HISTORIC AND DESIGN REVIEW COMMISSION

HDRC CASE NO: 2025-070
ADDRESS: 1024 BURNET ST
LEGAL DESCRIPTION: NCB 1660 BLK H LOT E 16.2 FT OF N 120 FT OF 6 & W 39 FT OF N 120 FT OF 7
ZONING: R-6, H
CITY COUNCIL DIST.: 2
DISTRICT: Dignowity Hill Historic District
APPLICANT: Richard Gonzalez
OWNER: Richard Gonzalez/NEXUS SERIES B LLC
TYPE OF WORK: Rear addition and deck construction, foundation and siding repair, window replacement, burglar bar removal, and fenestration and porch modifications
APPLICATION RECEIVED: March 14, 2025
60-DAY REVIEW: May 13, 2025
CASE MANAGER: Edward Hall
REQUEST:

The applicant is requesting a Certificate of Appropriateness for approval to:

1931 SANBORN MAP

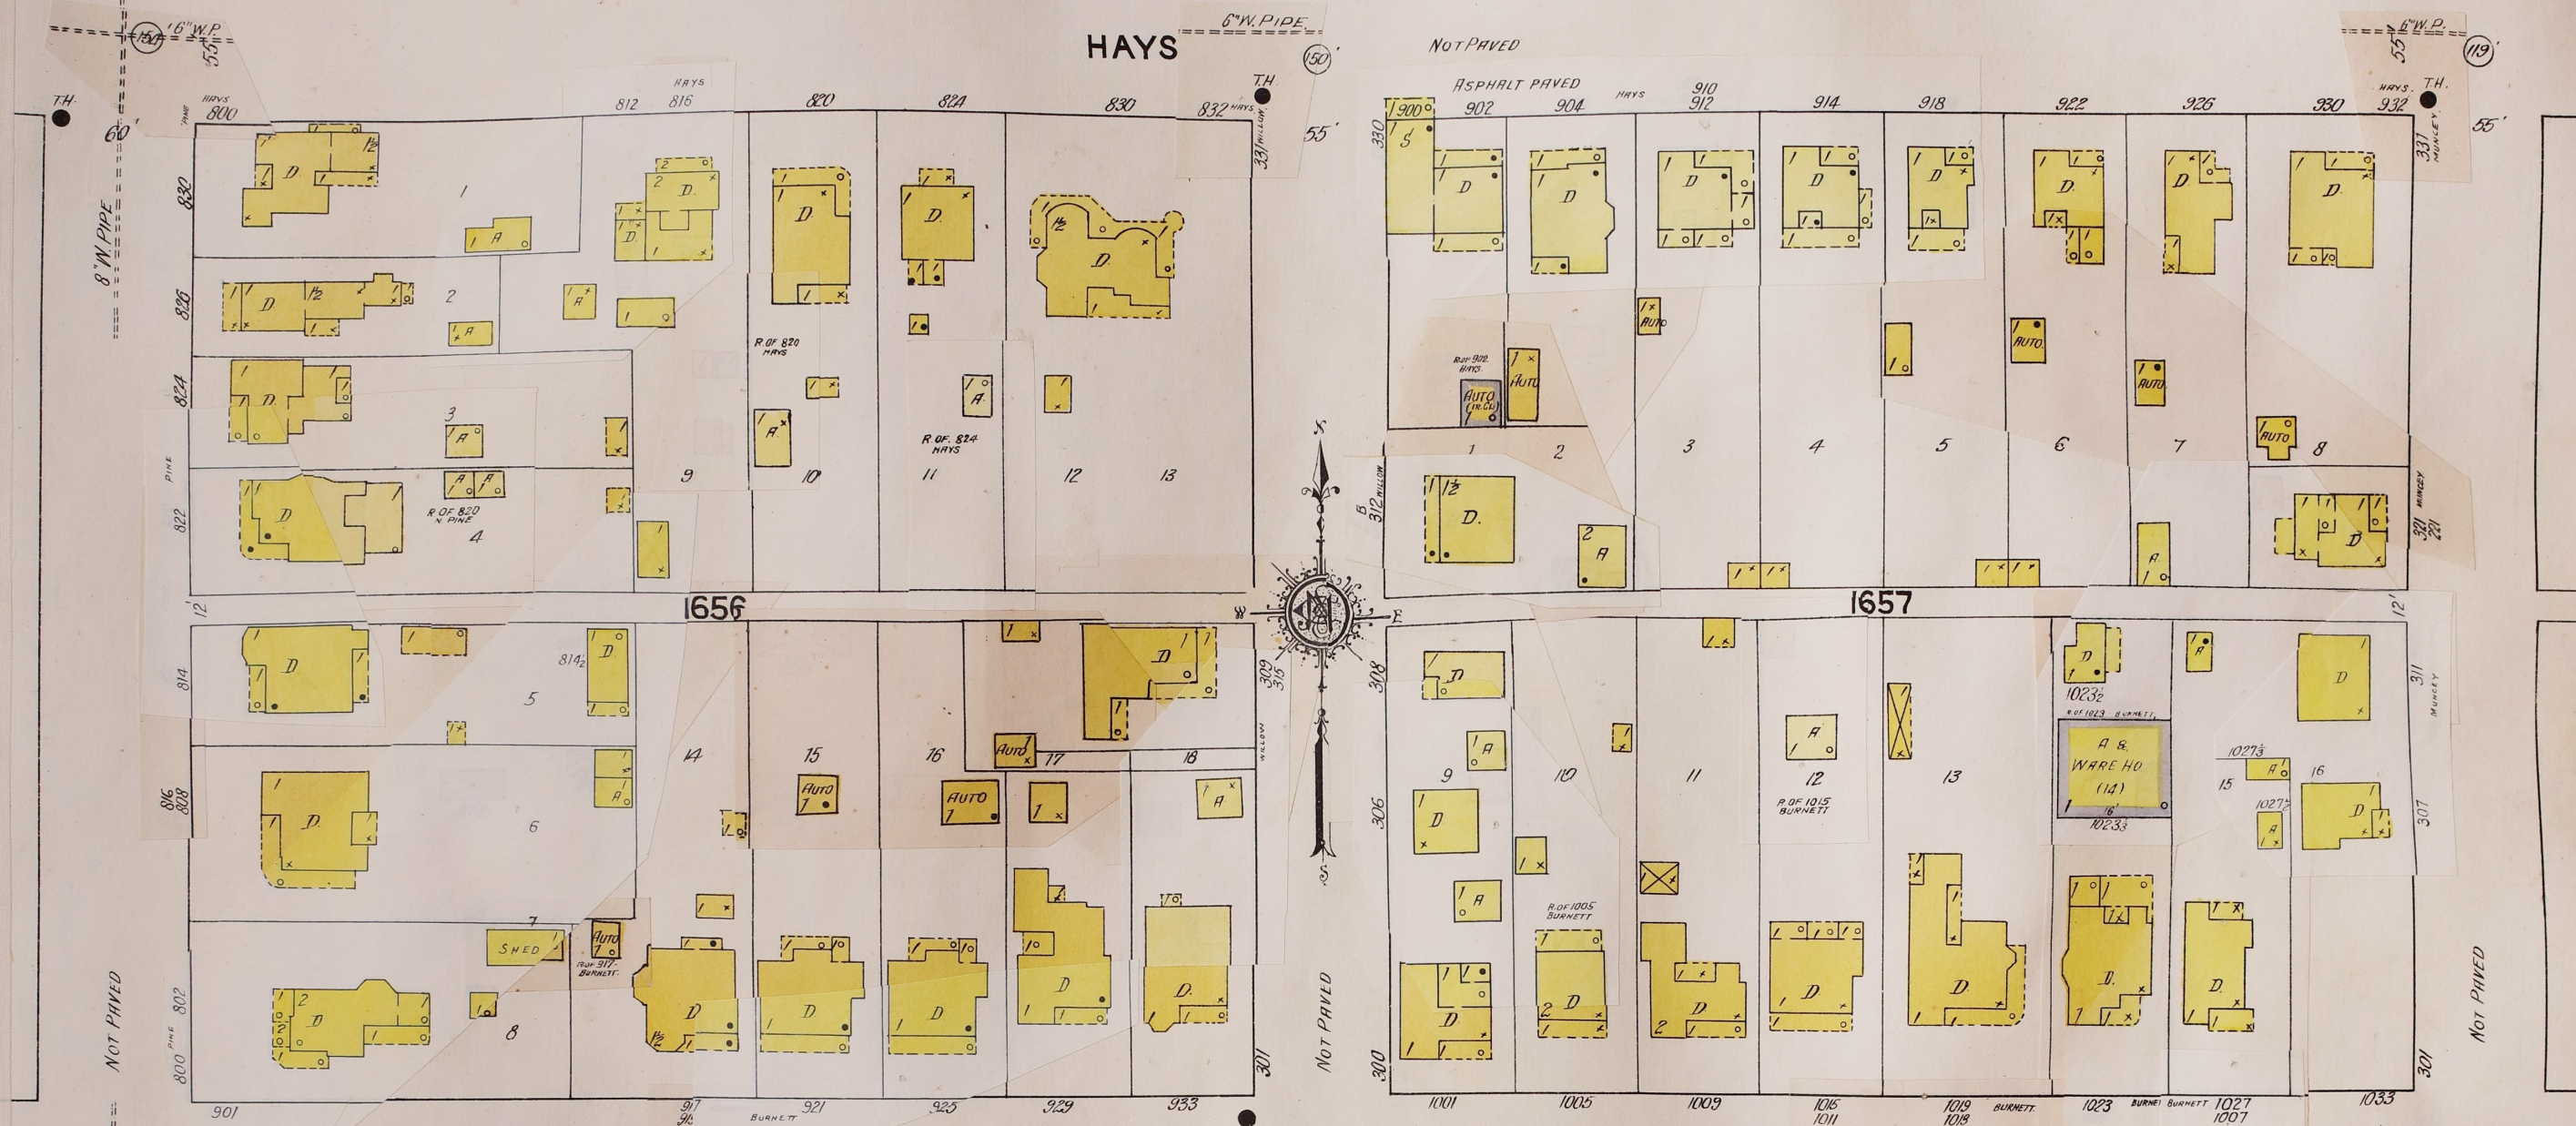
- f. REAR ADDITION – The applicant has proposed to construct a 1-story, rear addition to feature 518 square feet. The proposed addition will feature an asphalt shingle roof, a rear facing gabled roof with a rear covered porch featuring a hipped roof. The proposed addition will encompass an existing, rear wing of the historic structure. This existing rear wing is found on the 1931 Sanborn Map and is contributing to the structure.

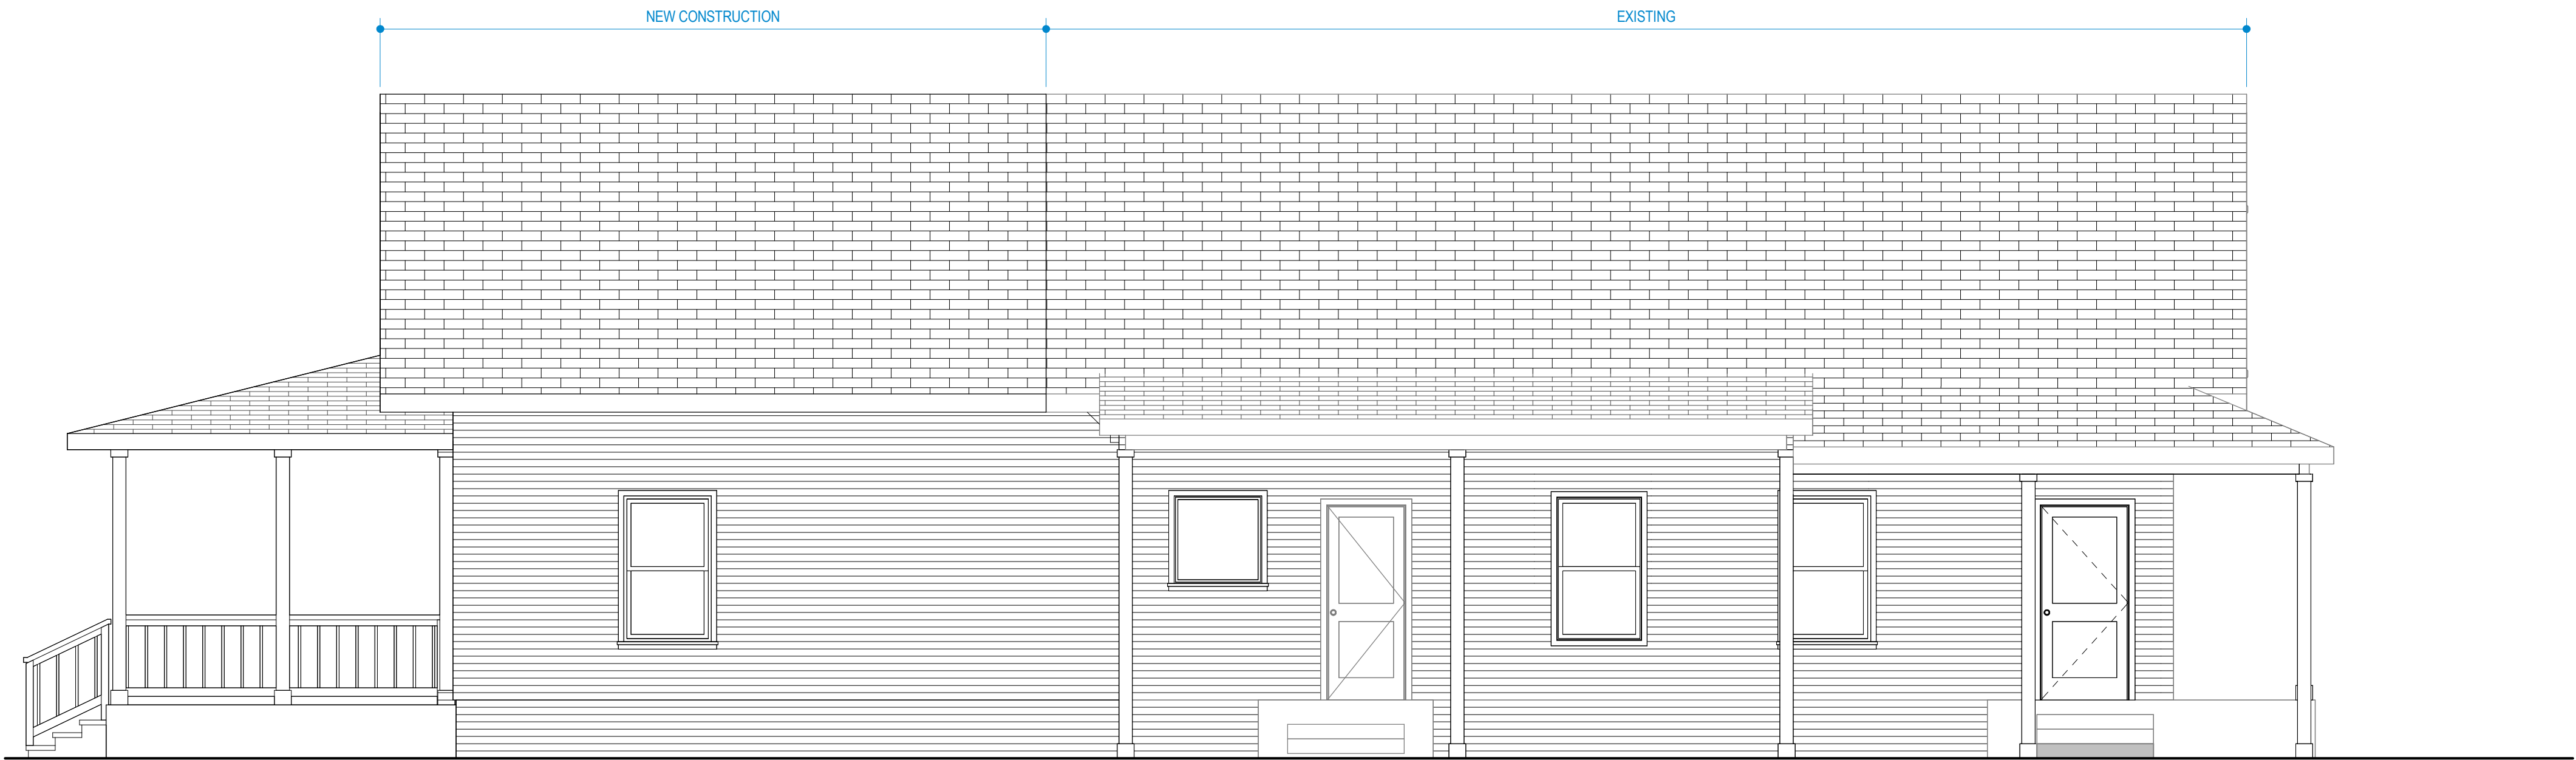
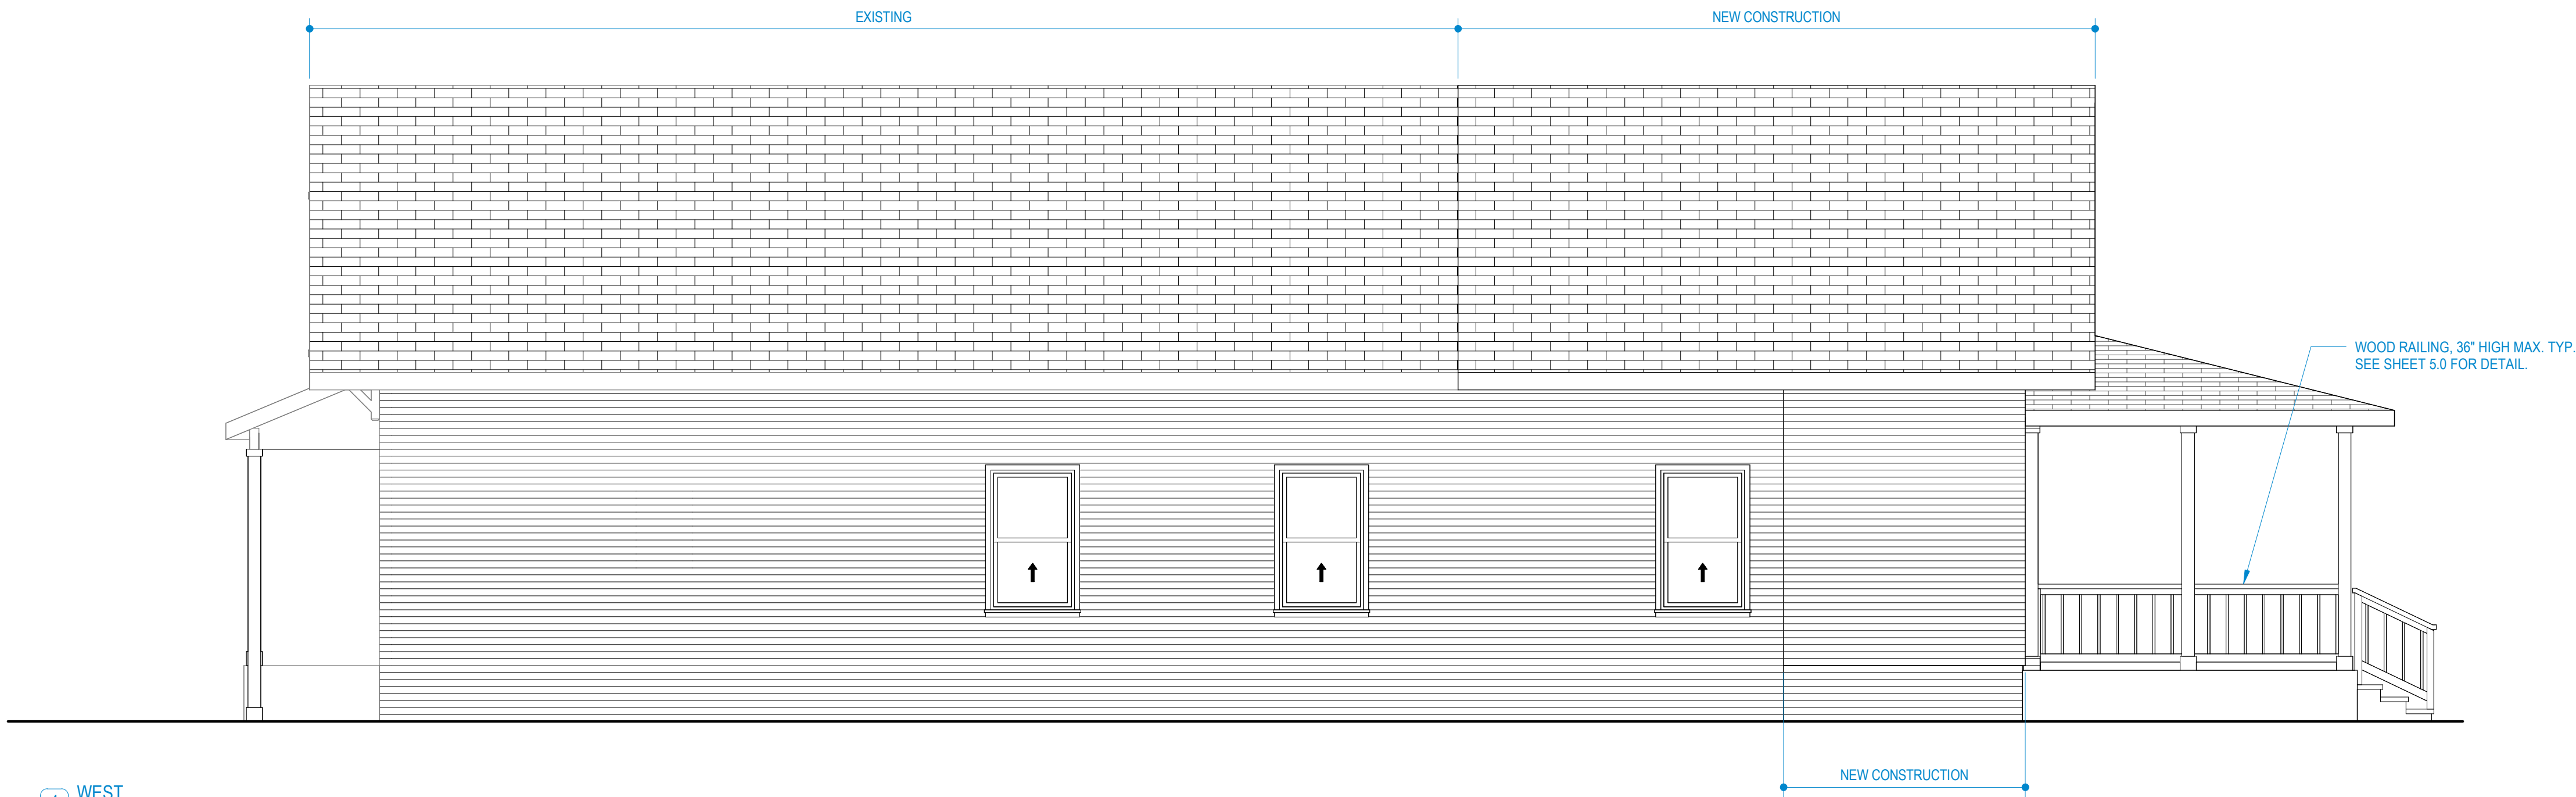
- g. REAR ADDITION (Footprint and Massing) – The Guidelines for Additions note that additions should be sited to the side or rear of the historic structure, should be designed in keeping with the historic context of the block, should feature a similar roof form and should feature a transition between the historic structure and new addition. Additionally, the Guidelines note that additions should feature similar architectural details and materials as the historic structure on the block and should not feature a footprint so large as to double the historic structure’s footprint. Generally, staff finds the proposed addition’s footprint and massing to be appropriate; however, staff finds that the proposed addition should either feature a setback from the original structure’s side facades or a vertical trim piece to differentiate the addition from the original structure.

- i. REAR ADDITION (Architectural Details) – The rear of the historic structure currently features a set of ganged windows within the rear facing gable. Staff finds that these windows should be reinstalled in the rear facing gable of the addition. As noted in the above findings, staff finds that a wall inset or vertical trim piece should be installed on both side facades where the addition meets the original structure.

- 4. Staff recommends approval of item #4, the construction of a rear addition based on findings f through i, with the following stipulations:
 - i. That the proposed addition feature either a setback from the original structure’s side facades or a vertical trim piece to differentiate the addition from the original structure.

- iv. That the set of ganged, wood windows currently within the rear facing gable be reinstalled within the addition’s rear facing gable.
